# Service Information

**Ride:** SEA DRAGON

# SERVICE BULLETIN

SEA DRAGON

BELLOFRAM DIAPHRAGMS

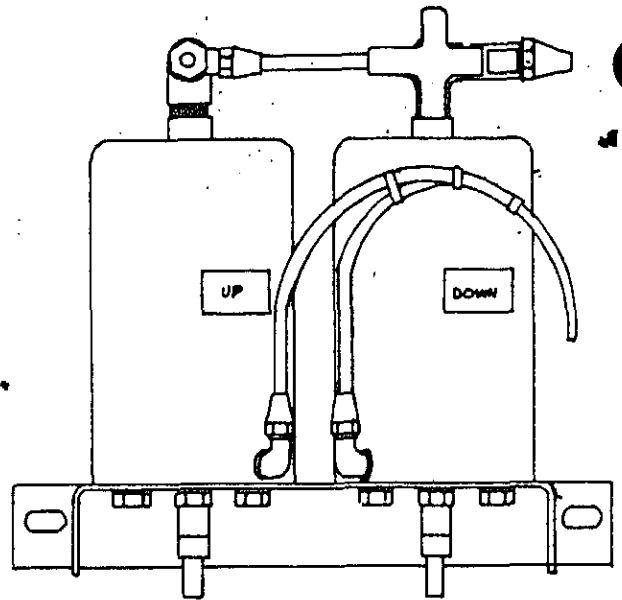
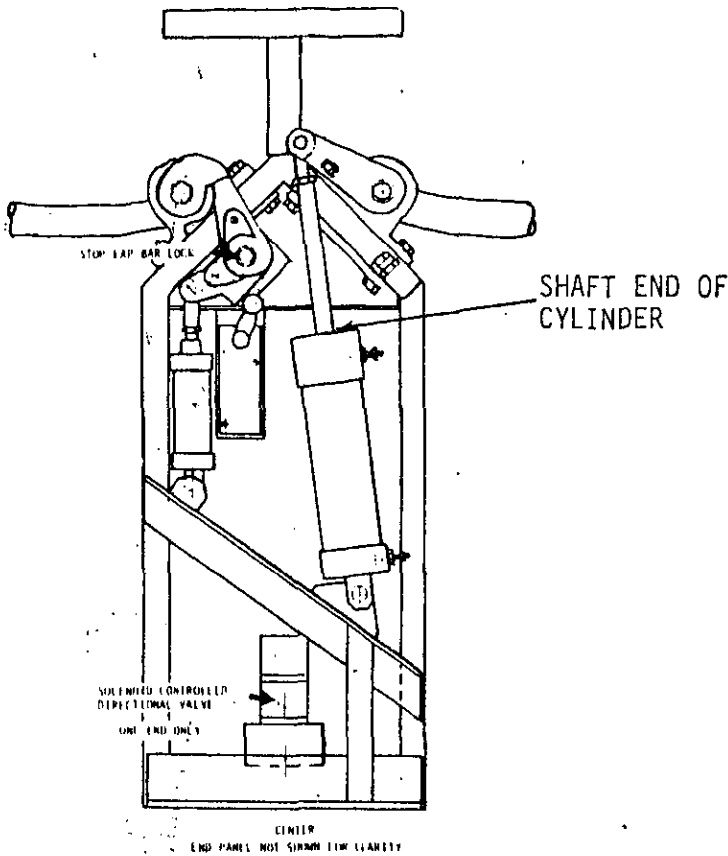
Therefore, we request all Sea Dragon owners make a thorough inspection of the lap bar cylinders and Bellofram diaphragms for hydraulic fluid leakage. This simple procedure is accomplished by removing seat end panels and checking for the presence of hydraulic fluid on or around lap bar components.

If fluid is present on either cylinders or diaphragms, Chance Manufacturing Co., Inc. has available through our parts department, replacement cylinders (#272-21708) or a diaphragm kit (which replaces a set of Bellofram diaphragms) #K72-0209-00.

NOTE: This kit replaces one set only, 5 sets must be ordered for complete boat change.

BOAT TILTED TO SIDE FOR EASE OF ILLUSTRATION

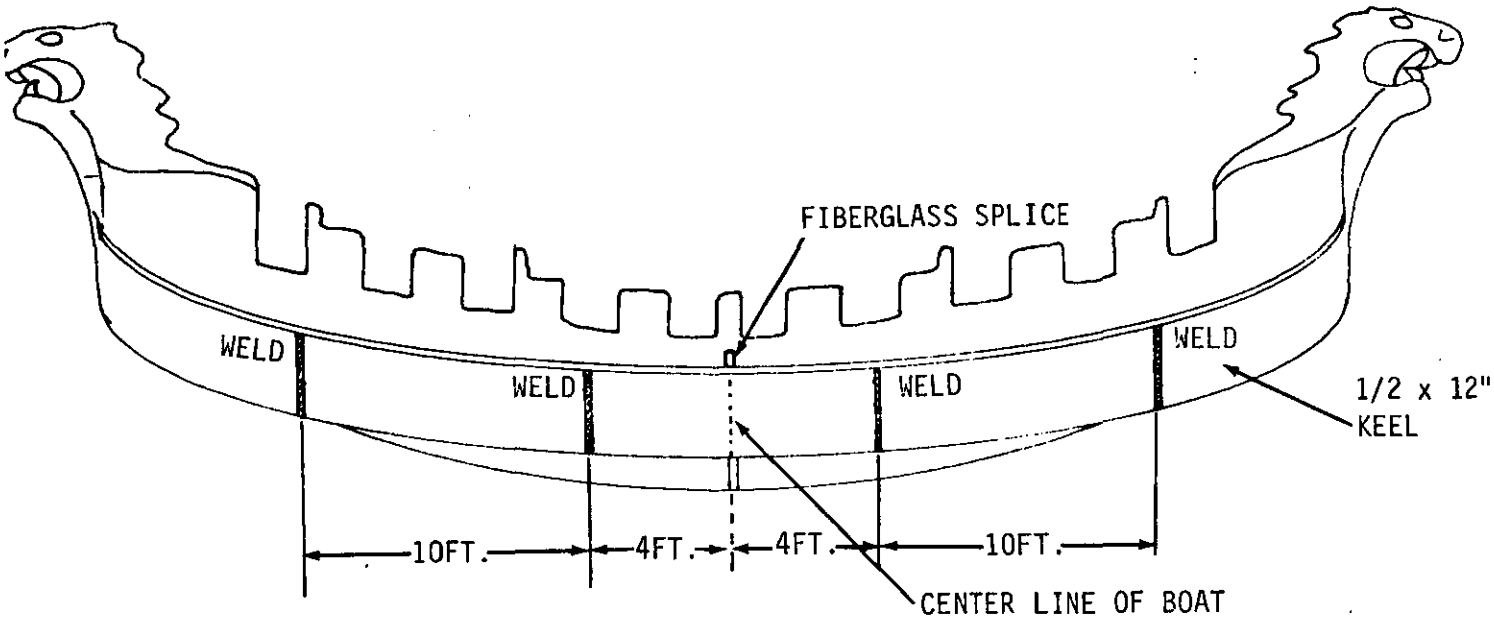
A condition has occurred on one ride in which cracks occurred in the welds on the underside of the boat keel. We are requesting that all owners of Sea Dragons immediately inspect the areas described in the following illustration, and report your findings to Chance Manufacturing Co., Inc.

Inspection of the four welds on the bottom of the keel should be made. Welds are located one to each side of center, approximately four (4) feet, and one approximately fourteen (14) feet either side of center (or ten (10) feet from first weld).

All welds should be visually inspected for cracks or signs of stress on a weekly basis.

ILLUSTRATION A

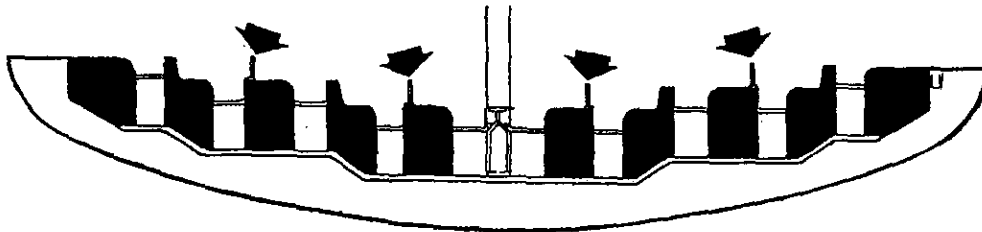
1. Remove both seat sides from the seats indicated in Illustration A.

ILLUSTRATION B

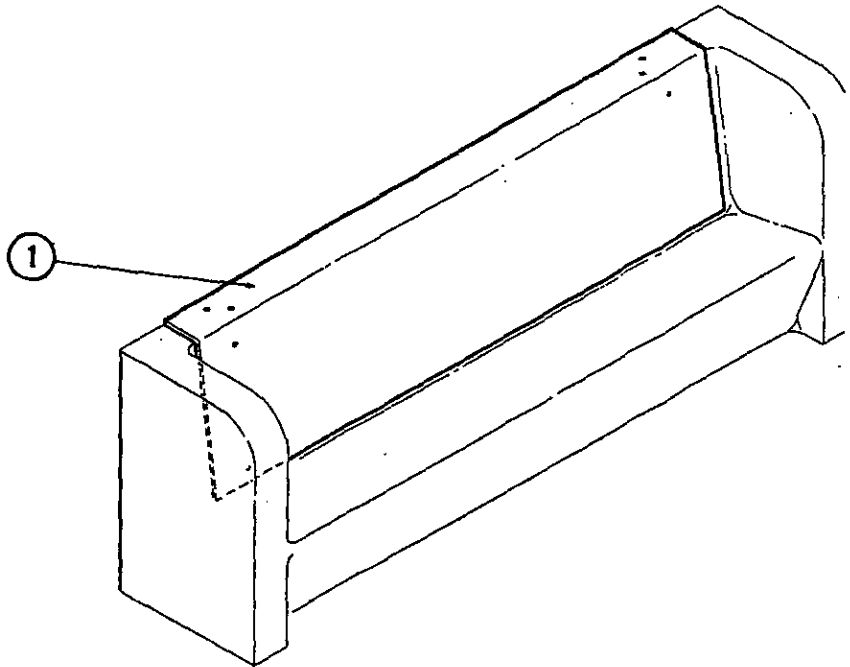
2. Position template (Item #1) over seat back, as shown in Illustration B. Center template and drill holes (8 places) marked by template using a 9/32" drill bit.

ILLUSTRATION C

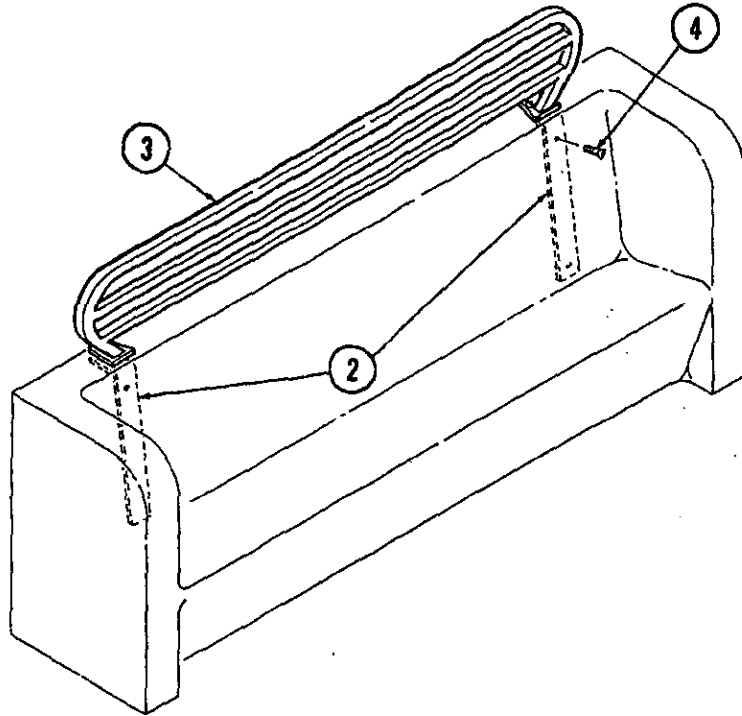
3. Install grab rail support braces (Item #2) as shown in Illustration C, on inside of seats with 1/4-20 x 1-1/4 bolts supplied with the kit (Item #4). Braces have tapped holes. Remove any rivet which prevents brace from sitting flush with seat back.
4. Mount grab rail (Item #3) on top of seat back as shown in Illustration C. Use 1/4-20 x 1-1/4 bolts to secure in place.
5. Repeat this procedure on the other three remaining seats as identified in Illustration A.

ILLUSTRATION D

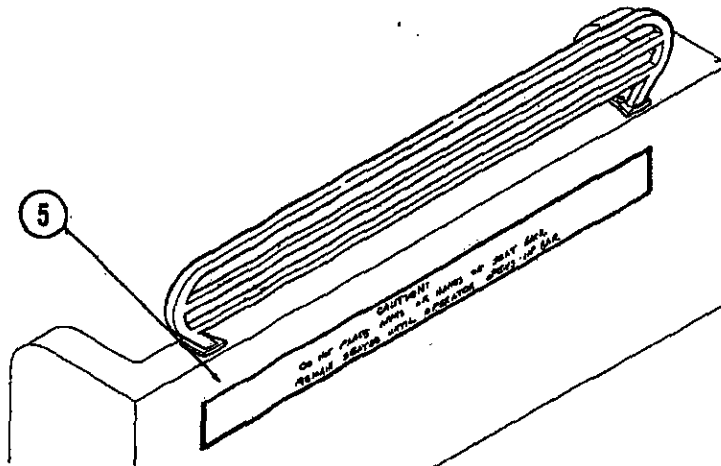
6. Mount safety decals (Item #5, 6, and 7) over old decals on seat backs and at mast area so that it is visible to the passengers, as shown in Illustration D.

INSPECT FOR CRACKS AT "A"

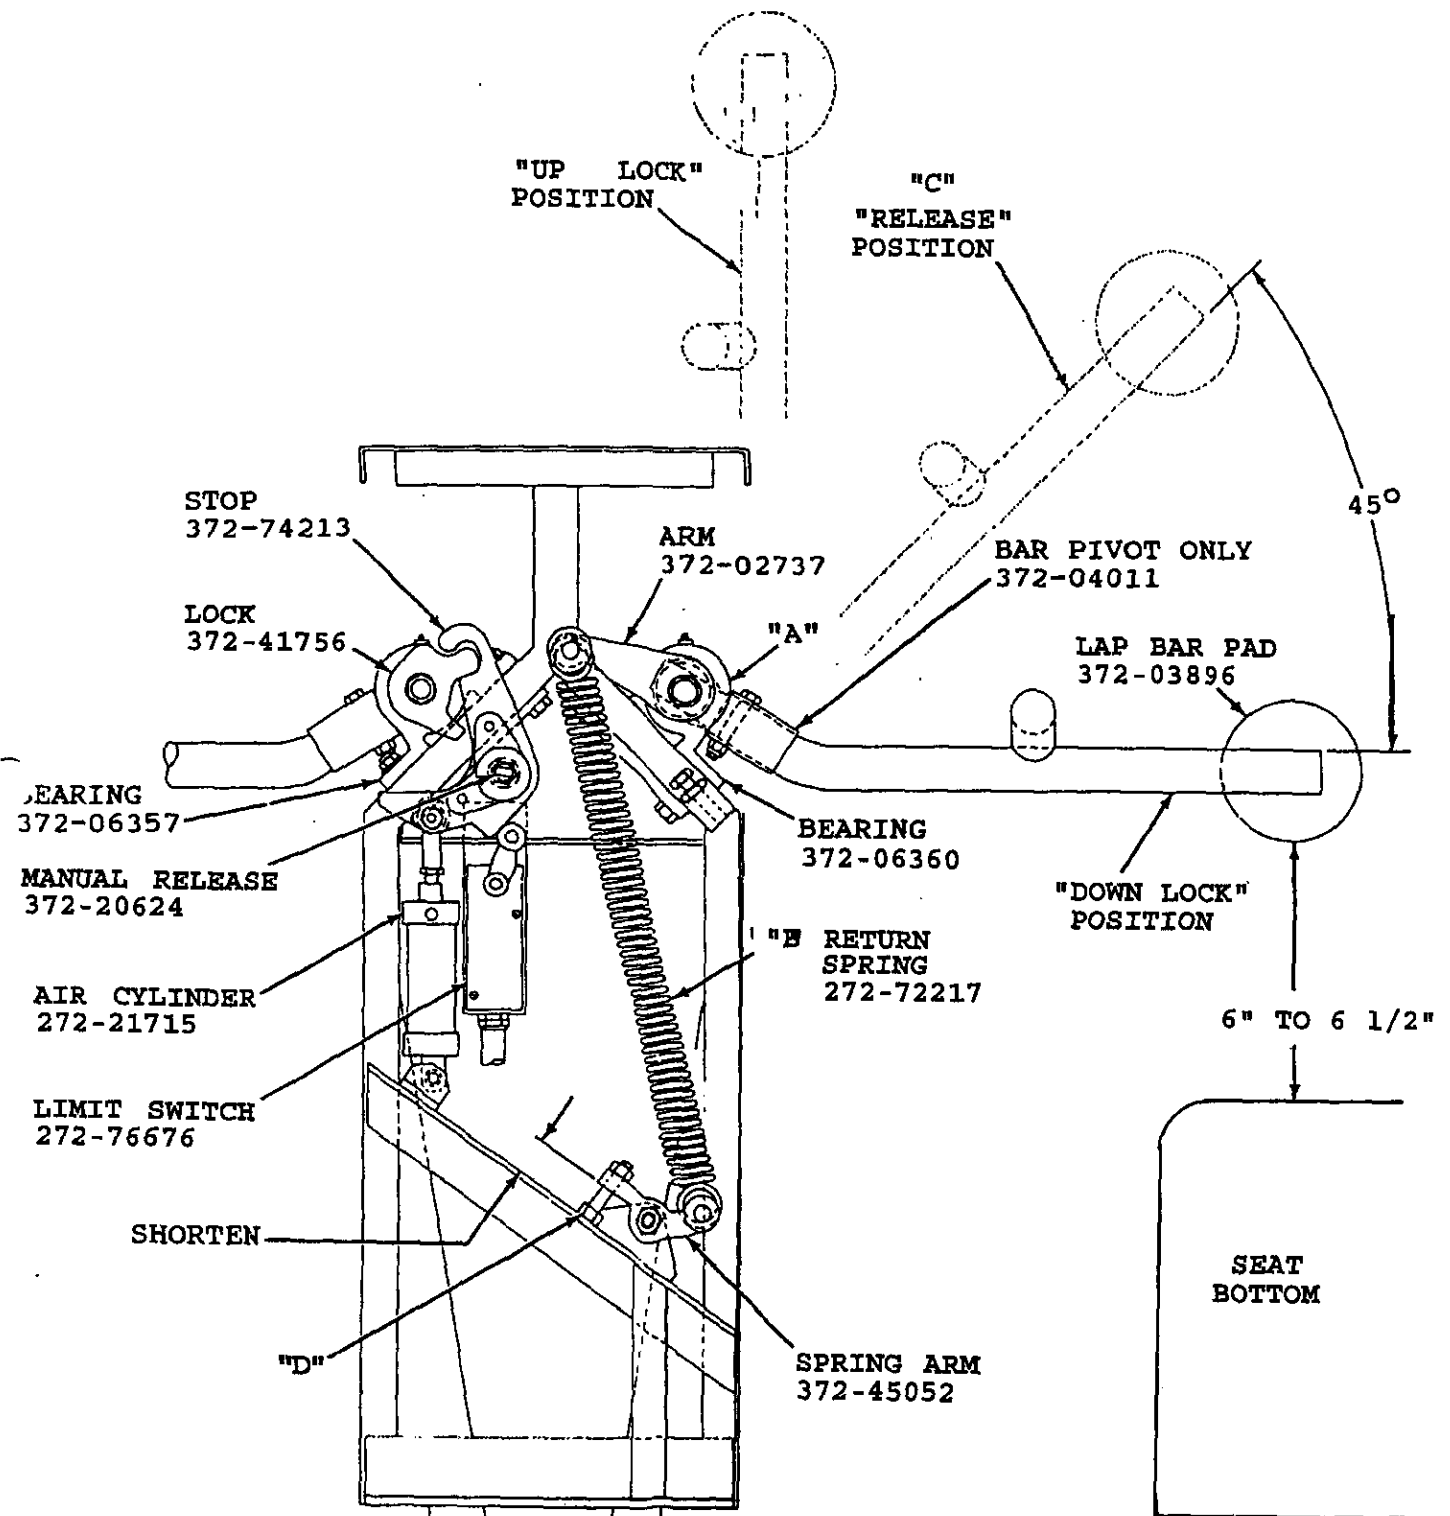
Chance Rides, Inc. requires all owners of SEA DRAGON amusement rides to inspect the lap bars for proper adjustment. If the lap bars are not adjusted properly cracks can develop adjacent to the weld joining the stainless steel lap bar to the main cross tube, as shown, as point "A" in the following illustration. If upon inspection it is found that the lap bars are out of adjustment, they must be inspected at both ends at point "A" for small cracks adjacent to the weld on the cross tube or the stainless steel tube. Report any cracks to Chance Rides, Inc.

Inspect the release of each lap bar to see that it does not slam into the "UP LOCK" position when released. Proper adjustment releases the bar from the "DOWN LOCK" position and lifts it upward so that it stops at approximately 45 degrees as shown in "C" allowing the passengers to move it on into the "UP LOCK" position.

Shorten the length of the stop bolt "D" to reduce the tension on return spring "B" until release of the lap bar is reduced so that it does not move directly into "UP LOCK" but swings up and settles at approximately 45 degrees as shown at "C".

Installation Instruction for Kit No. K387R1082-0.

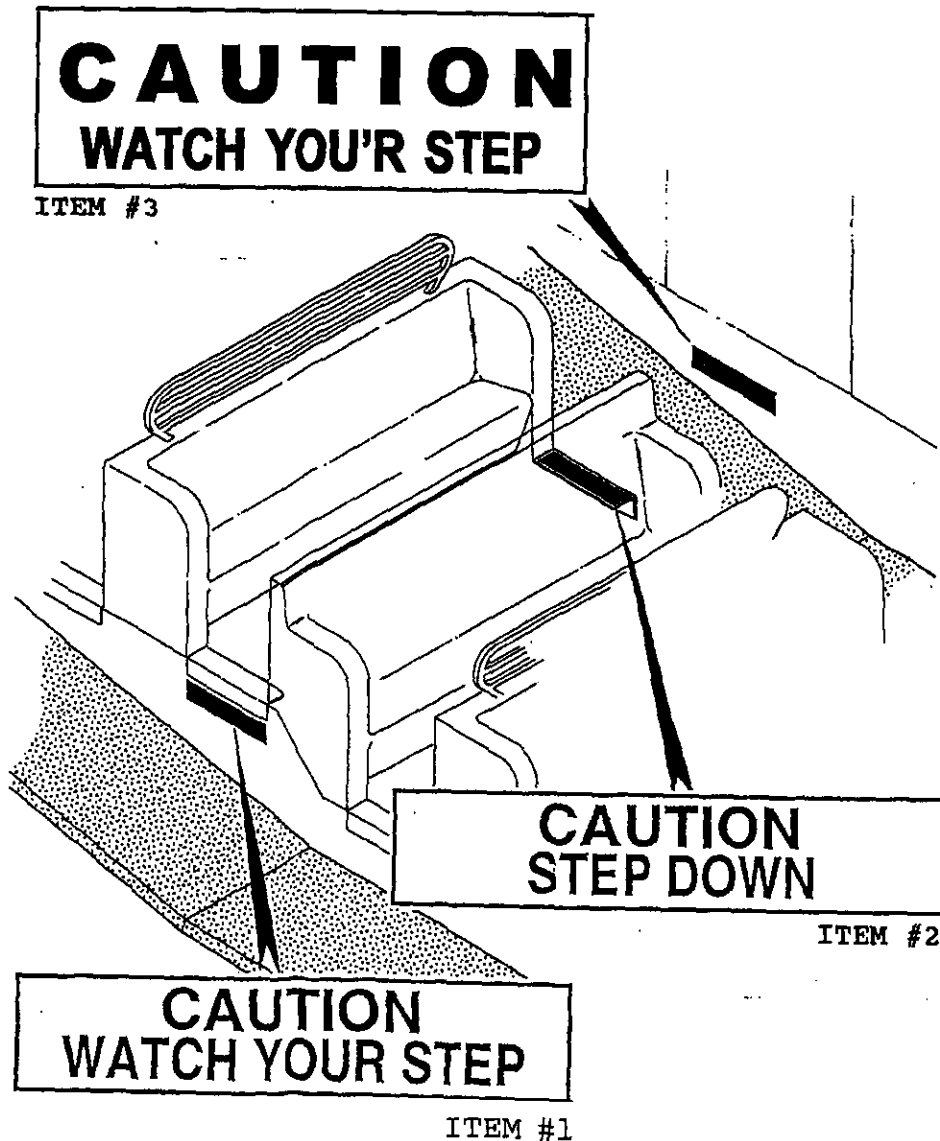
A safety decal kit has been developed to help alert persons, as they enter and exit the vehicle. Rides, Inc. requires all owners/operators of SEA DRAGON amusement rides to order the following kit and to install it as shown on the reverse side of this bulletin. Order kit number K387R1082-0 which contains the following decals. This kit is being offered free of charge, if ordered within 90 days of the date on this bulletin.

1. Apply one CAUTION - WATCH YOUR STEP (ITEM #1) decal just below the step sill of each of the 10 entrances to the vehicle.
2. Apply one CAUTION - STEP DOWN (ITEM #2) decal on the top of the step sill of each of the 10 exits from the vehicle.
3. Apply one CAUTION - WATCH YOUR STEP (ITEM #3) decal on the back drop just opposite and in line with each of the 10 exits of the vehicle.

NEW STYLE  
SPREAD CYLINDER SUPPORT WELDMENTS

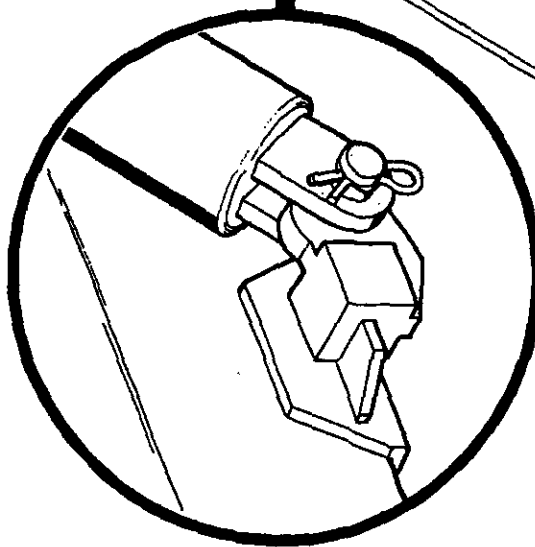
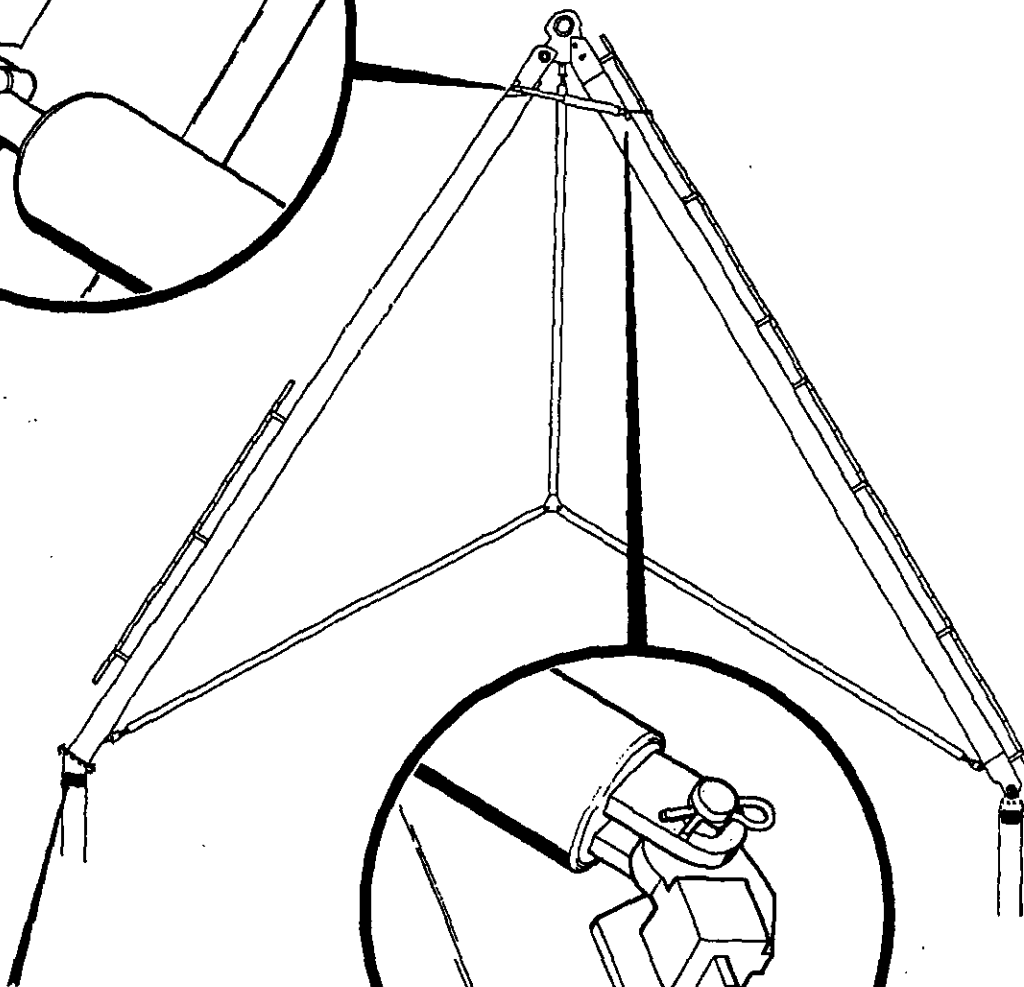
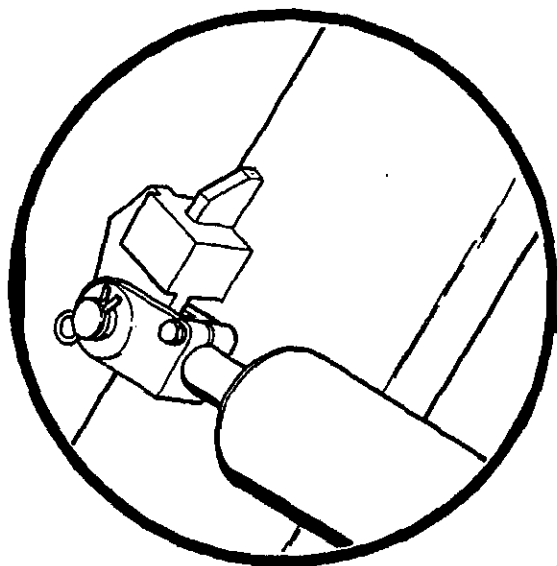
Chance Rides, Inc. has become aware that if the spread cylinders on the tower legs of the SEA DRAGON are fully extended or retracted with pressure still being applied to the cylinder, that damage to the cylinder attaching weldment and injury to personnel may occur. Chance Rides, Inc. has developed a kit which when properly installed increases the welded area of the cylinder attaching weldment to the tower leg.

In addition to this kit, proper set-up and tear-down procedures must be followed. Extend and retract the cylinders slowly, making sure that the cylinders and the clevises do not bind. Never extend or retract spread cylinders with tower legs resting on the stub towers. If the cylinders are fully extended or retracted the pressure to the cylinders must be stopped immediately. Never utilize more than 2500 psi when operating spread cylinder. Stay clear of tower legs when extending or retracting the spread cylinders. All owners of SEA DRAGON amusement rides are to order and install four (4) decals number 22193005 as shown on this bulletin, one per stub tower.

APPLY DECAL TO STUB TOWERS  
(4 PLACES)

## AIR CYLINDER INSPECTIONS

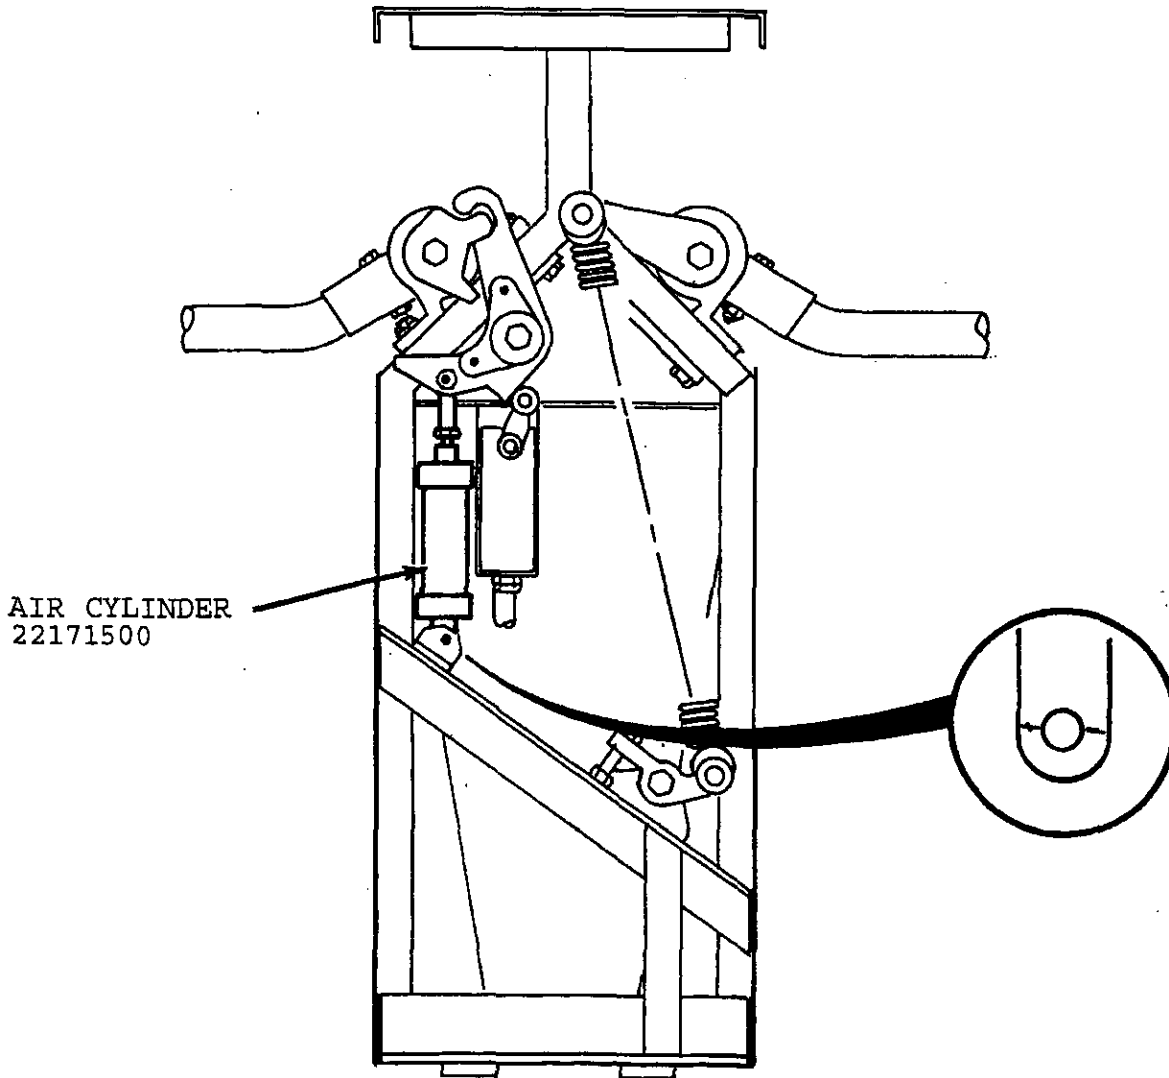
Chance Rides, Inc. has had reports of the bottom mounting eye of the lap bar air cylinders breaking. These cylinders activate the lap bar locks. The breaks occur at the point where the cylinder is pinned to the seat frame. All owner/operators of SEA DRAGON amusement rides are required to visually inspect the air cylinder attaching points for cracks. If any cracks in the cylinder attaching points are found, the cylinder must be replaced. This inspection must be done on an annual basis

If any cylinders have been replaced, due to either the above inspection or due to previous breakage in this area, adjustment to the air pressure may be required. It has been determined that failure of the cylinders may be due to improperly regulated air pressure. The air pressure at the boat should not exceed 45 psi.

NOTE: Lap bars must be in the up position and air cylinders unpinned at bottom in order to perform inspection. Cylinder must be repinned before operating ride.
